Inglewood Park Upgrade

Community Feedback

Between the 19 August and 1 September 2024 Melton City Council shared with the local community of Inglewood Park, Burnside Heights a proposed landscape plan to upgrade the existing park.

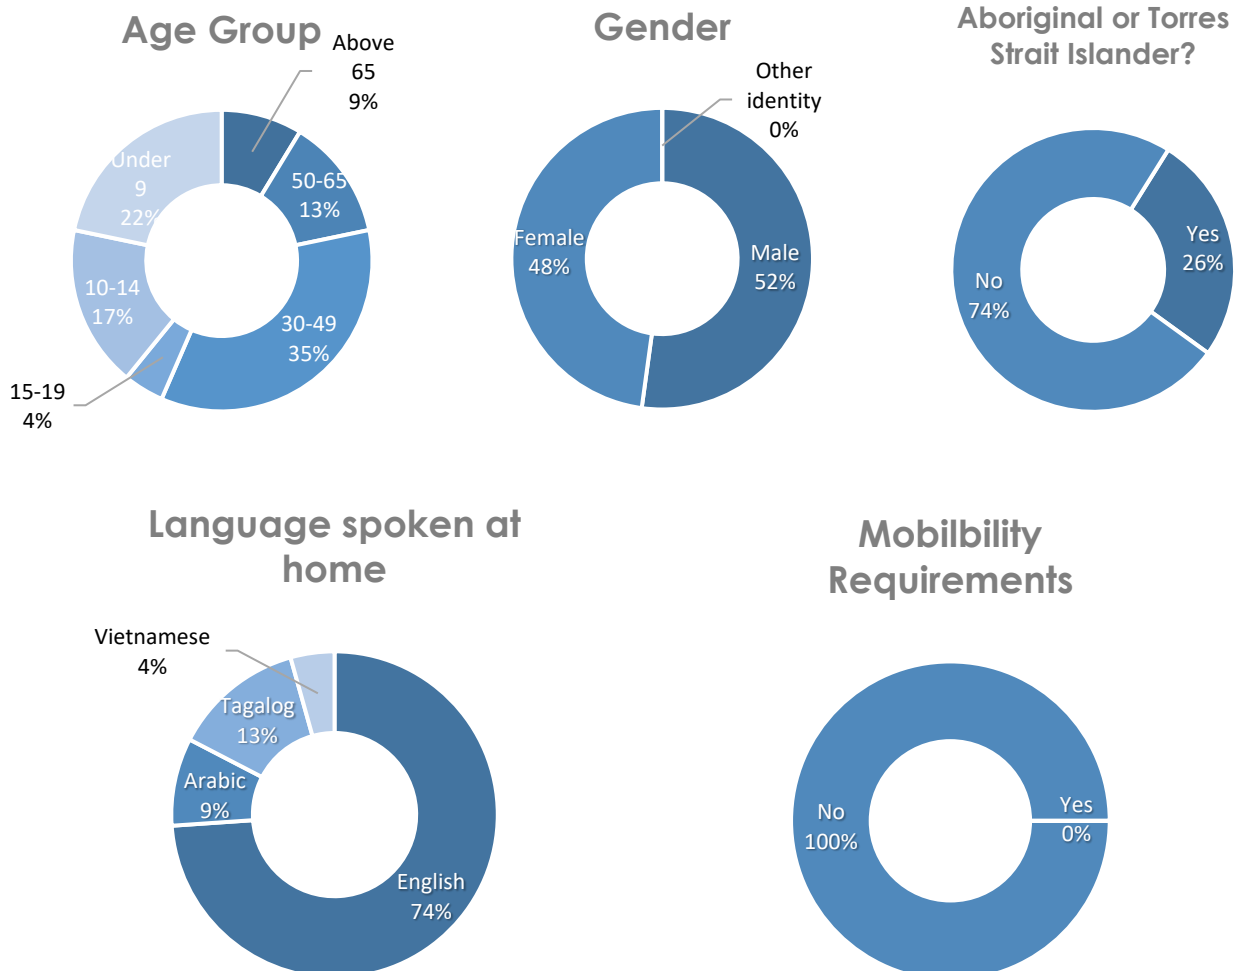
Community Feedback	Melton City Council Response
General	
Expand the scope of upgrade work	This will be reported to the open space planning team and reviewed or inclusion in future infrastructure plans.
Better maintenance of the park	This will be reported to Council's relative department.
Improve the planting in the existing garden beds	This will be reported to the open space planning team and reviewed for inclusion in future infrastructure plans.
Include BBQ	BBQ facilities are typically not included for a local-level reserve.
Include Drinking Fountain	Drinking fountains are typically not provided for a local-level reserve.
Include Toilet	Toilets are typically not considered at local-level reserves, which may raise safety concerns.
Include exercise equipment	This will be reported to the open space planning team and reviewed for inclusion in future infrastructure plans.
Include a fenced dog park	This will be reported to the open space planning team and reviewed for inclusion in future dog parks strategy.

Playground	
Address the snake hazard concern at the existing bush maze	This will be reported to the maintenance team.
Address the risk of burns from the existing sculpture in hot summer.	This will be reported to the maintenance team.
The play space needs to cater to a wider age range, not just toddlers.	This will be considered in the detailed design phase.
Include basketball court	This will be reported to the open space planning team and reviewed for inclusion in future infrastructure plans.
Include footy/soccer goals.	This will be considered in the detailed design phase.
Include running tracks.	This will be reported to the open space planning team and reviewed for inclusion in future infrastructure plans.
Include slides	Included.
